Additional comments on the Fast-Track Approval Act 2024 – Matakanui Gold Limited – Substantive Application for the Bendigo- Ophir Gold Project

In this supplementary submission we focus on the applicant's RFI 11 responses as they relate to the re-issued Water Management Plan of June 2026 (the Plan).

Figure 1: Adaptive Management Plan-Do-Check-Act Process

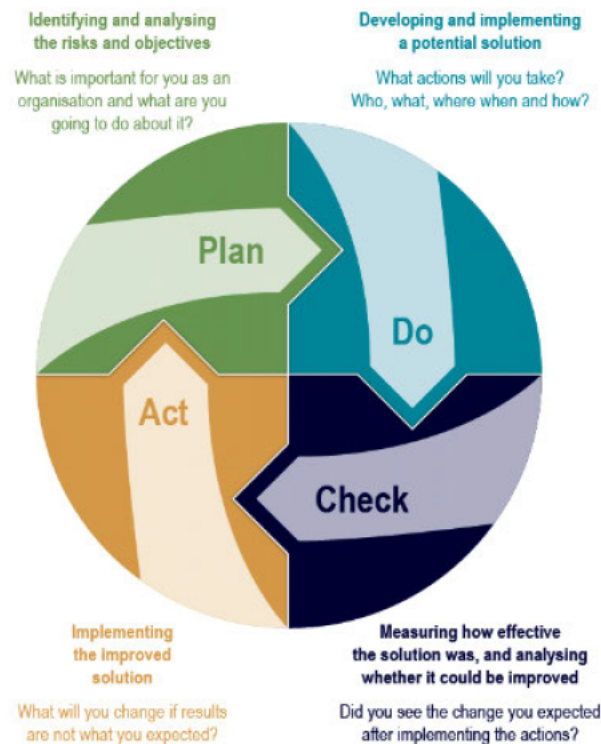
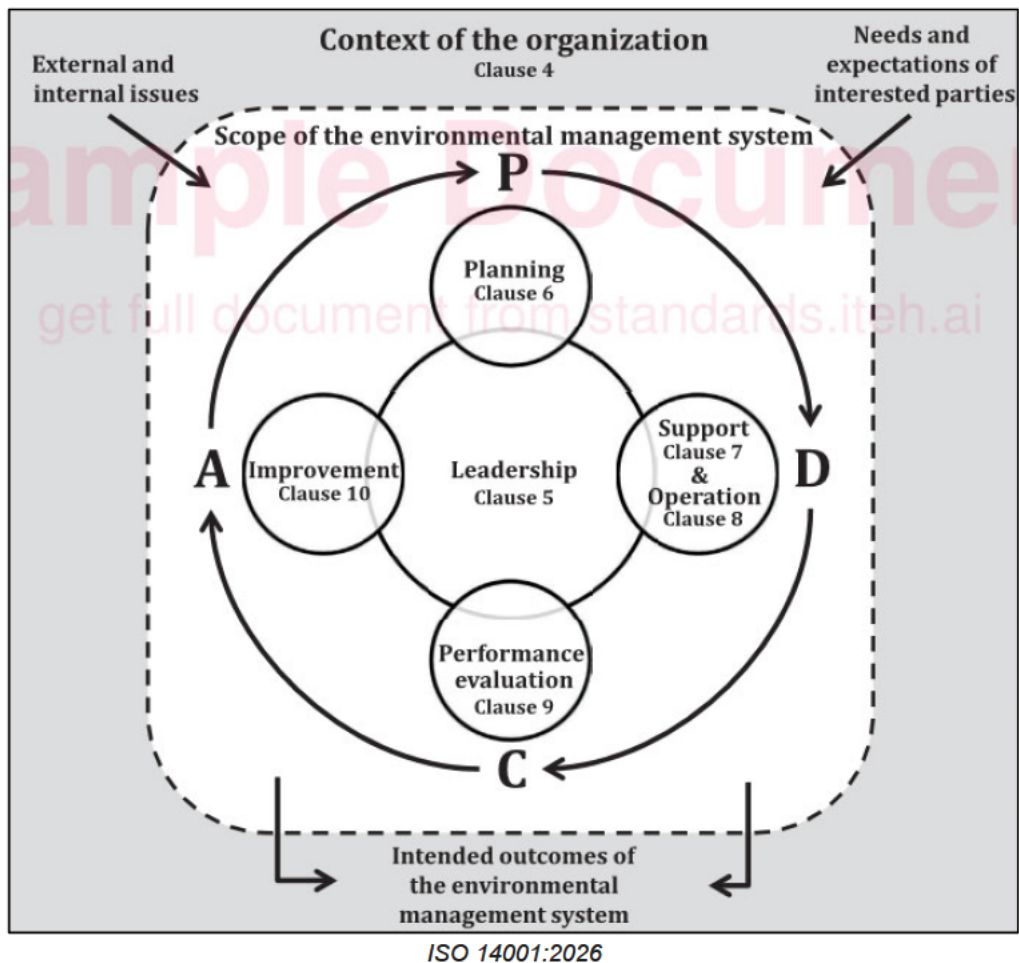
It is worth noting that the global standard ISO 14001:2015 (on which AS/NZS ISO 14001:2016 is substantially based) has been replaced with ISO 14001:2026⁵. A new schematic, imaged below, has now been developed to understand the process, along with further refinement of the standards.

The ISO describes the new standard thus, “**Environmental responsibility is no longer defined by commitments alone, but by the ability to demonstrate real, measurable performance.**”

There are a number of changes in the new standard. One of note, Clause 6.1.4 on *Risks and opportunities* states that, “**...environmental aspects need to be assessed. This specifically includes emergency situations ...**”

We further note that the updated AS/NZ version⁶ is currently being edited and that it is anticipated that this new standard will be published in September 2026. Given the Applicant's heavy use of Adaptive Management in its application, we ask that they adopt all areas of the new standard **and apply its principles** prior to any consent being granted.

Otago Regional Council – Regional Plan for Water - Map C Series

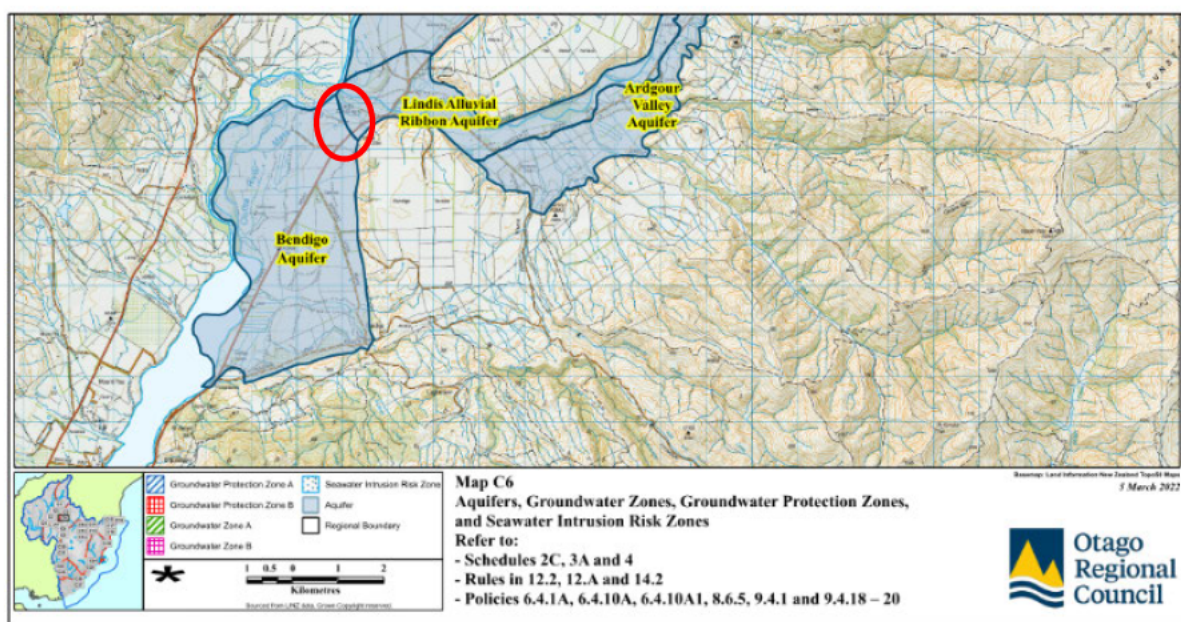
We note that is no mention of the Lindis aquifer and there is only one mention of the Ardgour aquifer in the entire Water Management Plan. All other references to these areas are described as in euphemistic terms - the 'receiving environment, receiving streams, receiving water bodies or receiving groundwater systems'. Equally there are no images of the Ardgour or Lindis aquifers in the Plan. This is added below.

We also note that there has been simply no analysis on the interaction between the Lindis Alluvial Ribbon Aquifer (LARA) and Bendigo aquifers. This is the area circled in red above and incorporates our property.
